City of Prescott
Prescott Preservation Commission

TO: MAYOR AND CITY COUNCIL
AGENDA: April 10 Prescott Preservation Commission
DATE: April 10, 2026
DEPT: Community Development
ITEM #: 3.B
SUBJECT: **HP26-003:** A Request for Approval of Revised Wall with Fencing and Patio Cover from Previous Approval for Doc's BBQ & Whiskey. Location: 202 S Montezuma St. Owner: Montezuma Goodwin LLC. Applicant: DOGE Construction.

Re: Design Review of proposed Doc's BBQ signage and patio addition at 202 South Montezuma Street (APN 109-02-046A), Prescott, Yavapai County, Arizona.

HP26-003: Revised Doc's BBQ & Whiskey Exterior Improvements

Elevations

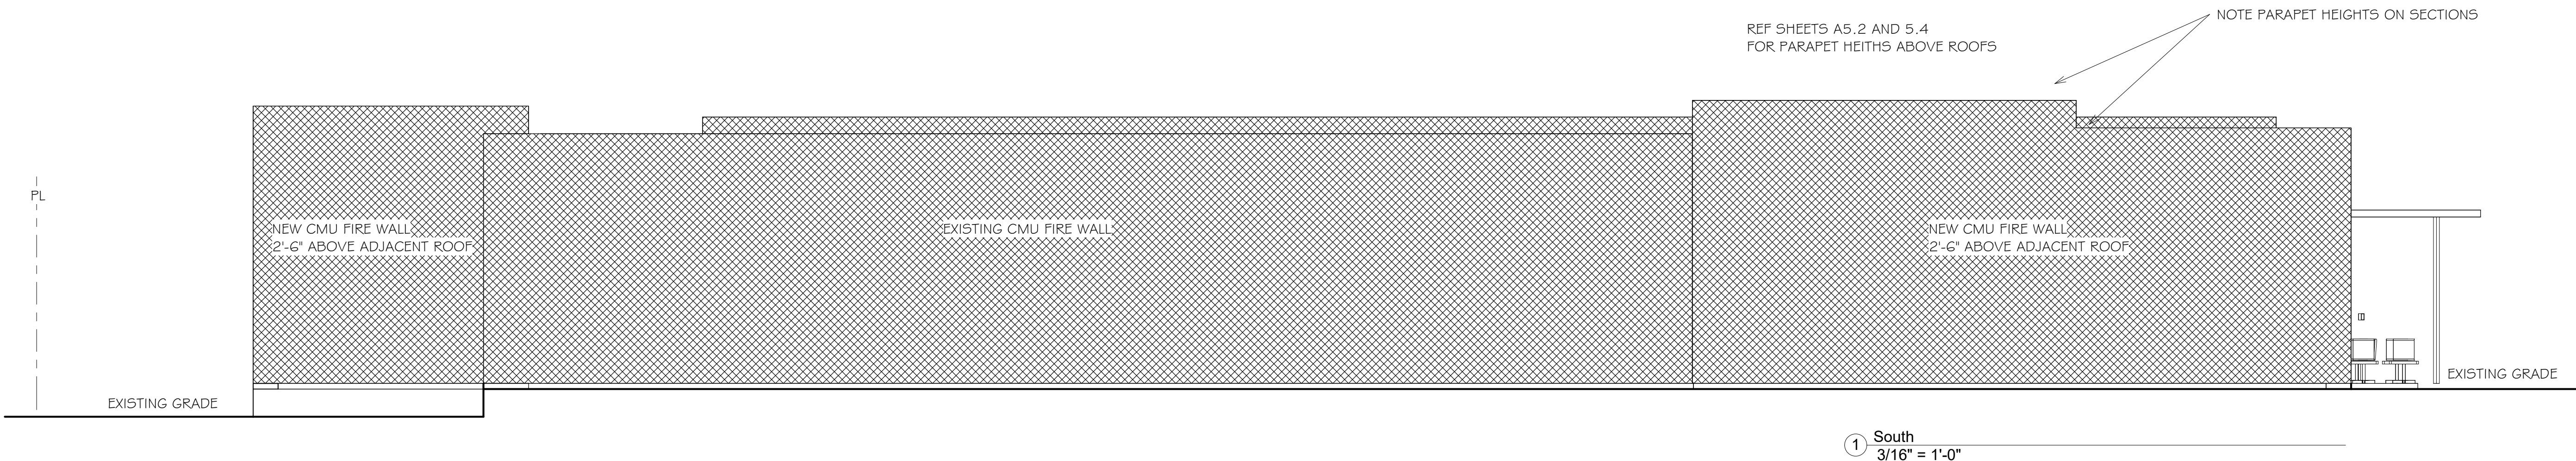
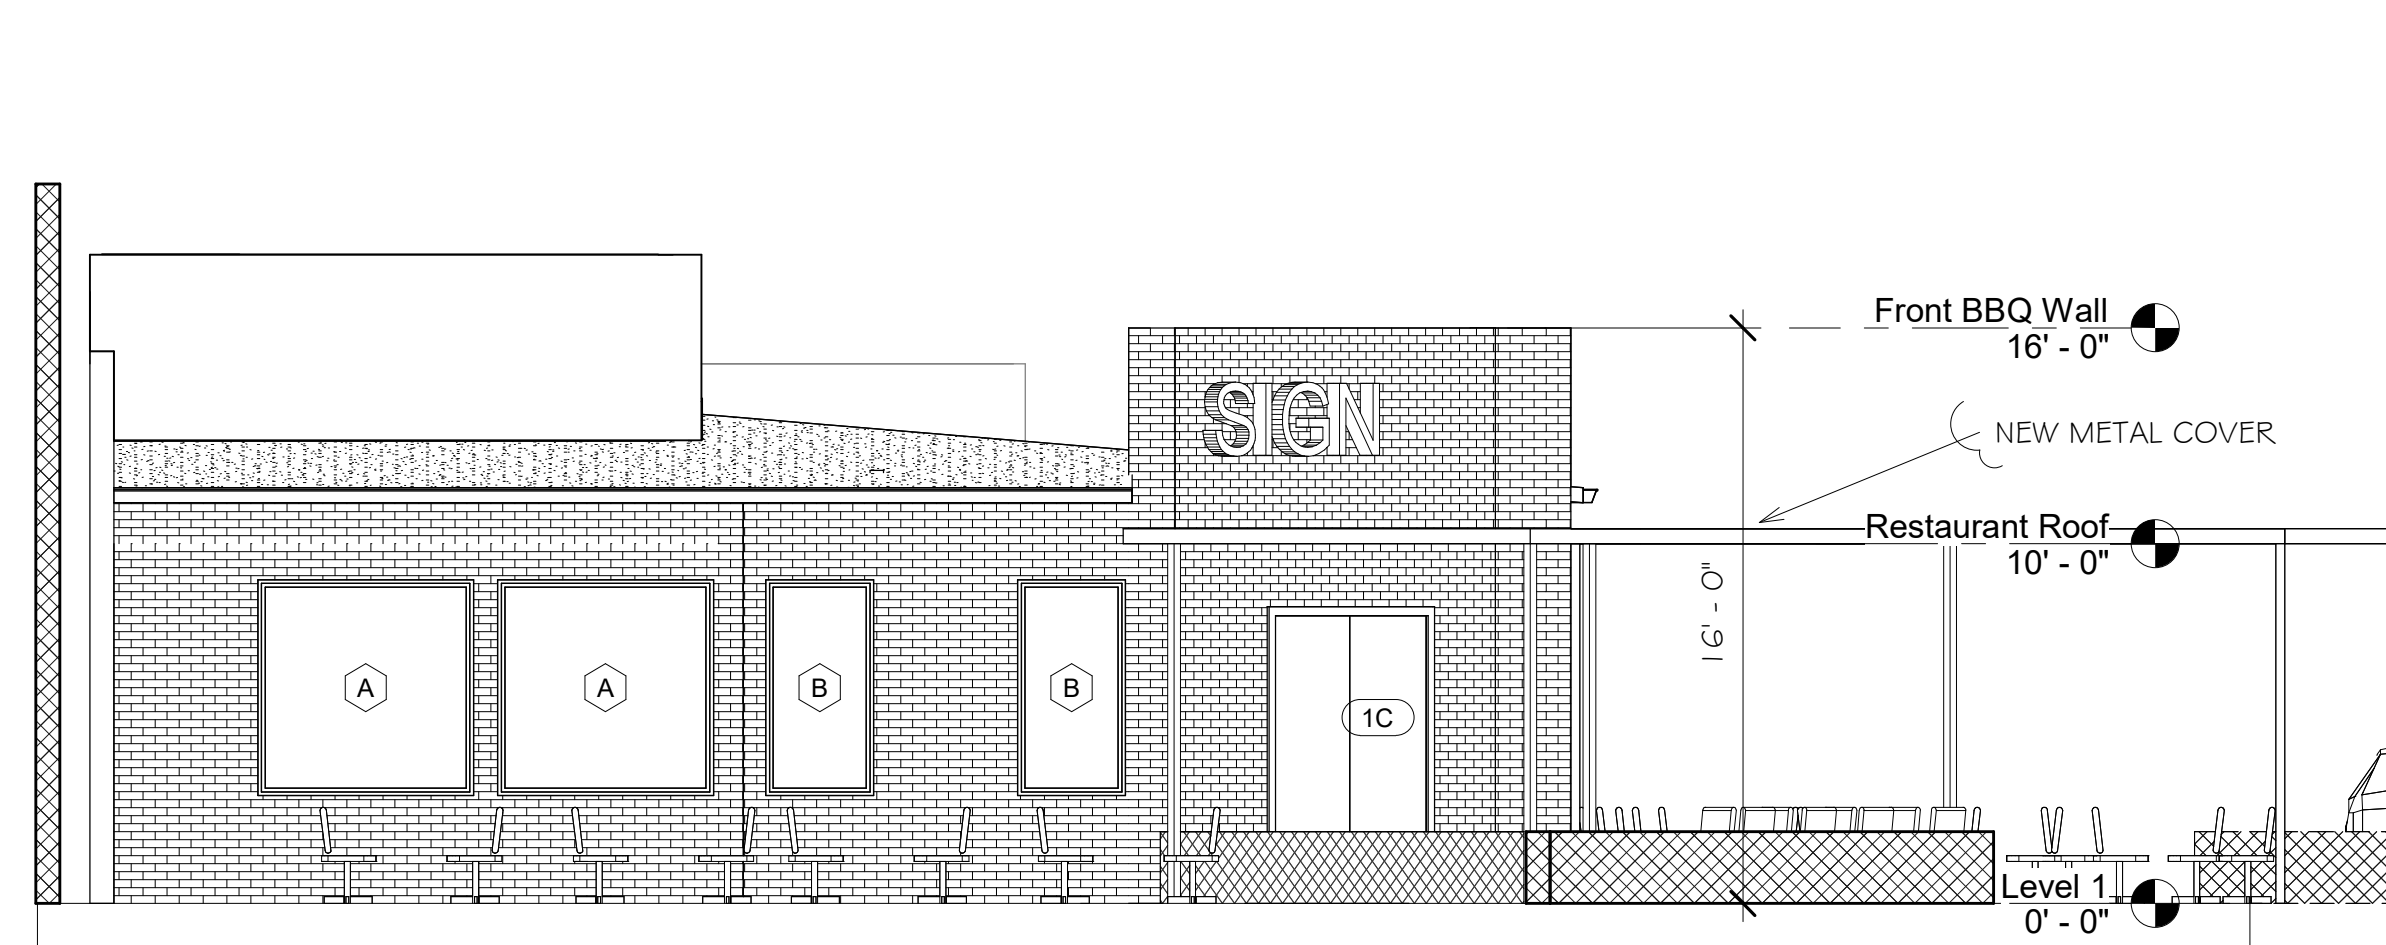
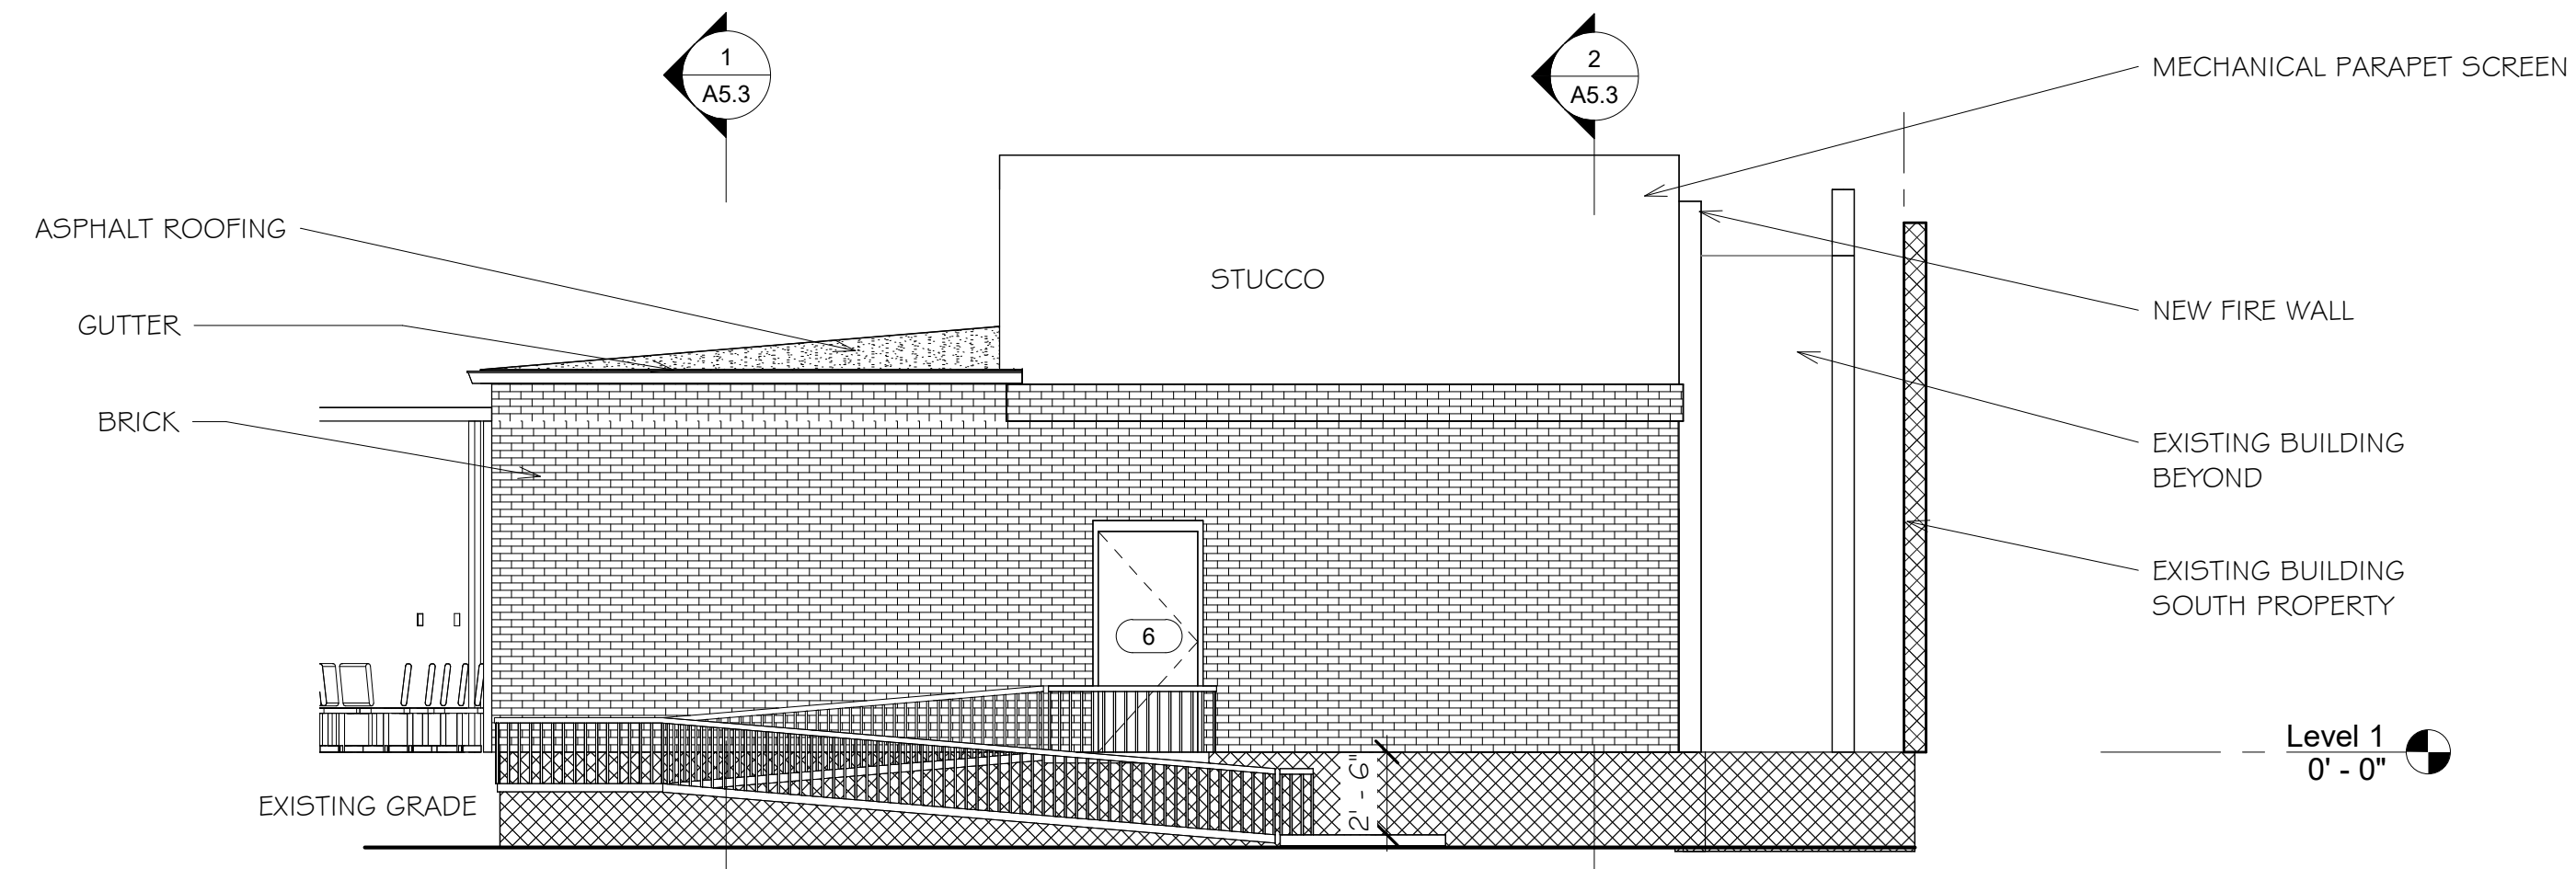
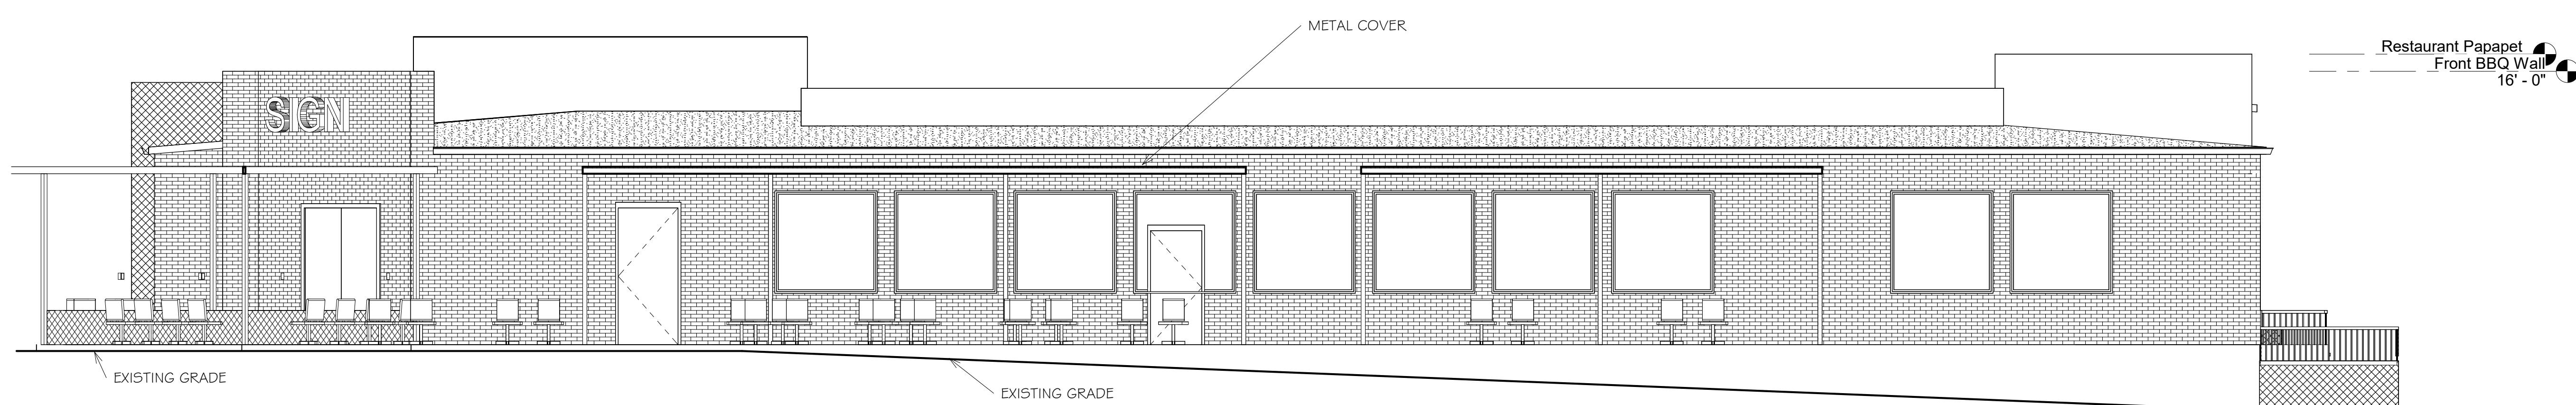
A revised patio cover plan was submitted that includes three patio covers of varying depths as opposed to two patio covers of consistent depth. The approved patio covers were sloped; whereas, the revised plans exhibit flat patio covers.

Broadbent finds that the proposed redesign of the patio covers meets Standard 9 in that it will be compatible with the adjacent historic buildings, specifically, existing historic materials, features, size, scale and proportion, and massing. Additionally, the reduced slope of the proposed patio covers will further minimize the visual impact from the public right-of-way, and the covers and frame will be black in color to blend in with the existing building color palette. Corrugated metal is the current approved patio cover for the northeast patio of the subject property; however, the applicant proposes the use of a more modern alternative, such as standing seam metal, for the patio covers. This material meets Standard 9 that encourages the use of compatible yet modern materials and construction methods so as to differentiate new construction from existing historic buildings and districts.

Proposed Covered Patio Locations

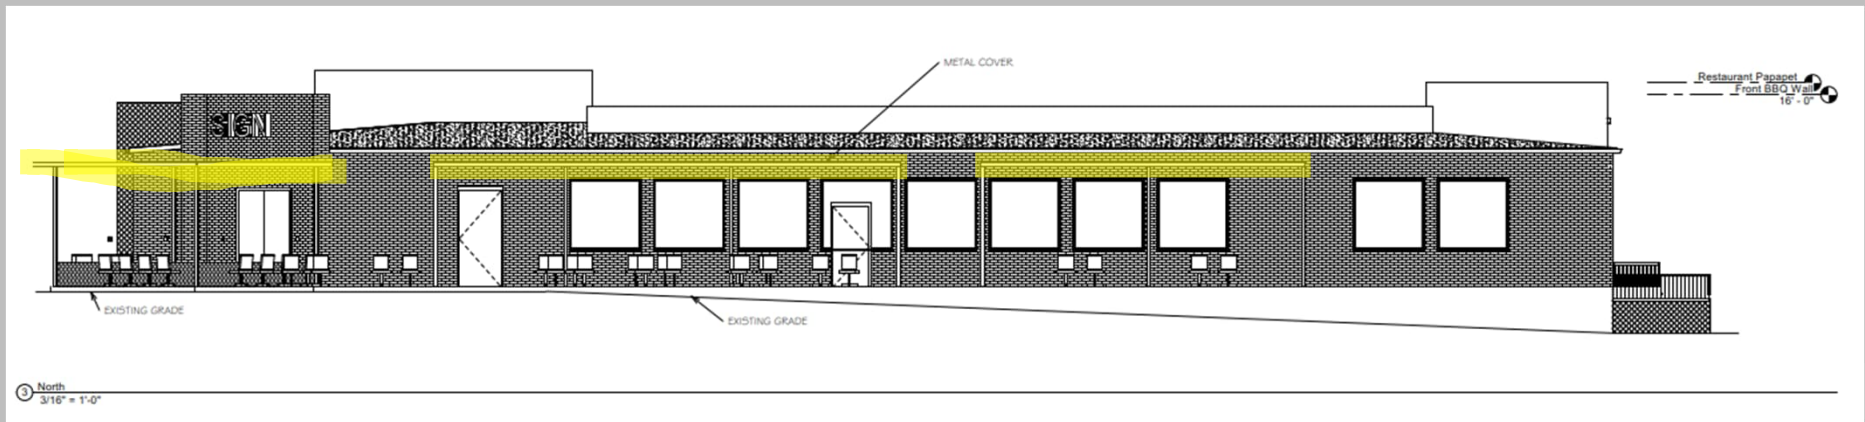
Install metal-frame and standing-seam metal flat patio covers, painted black to match the building.
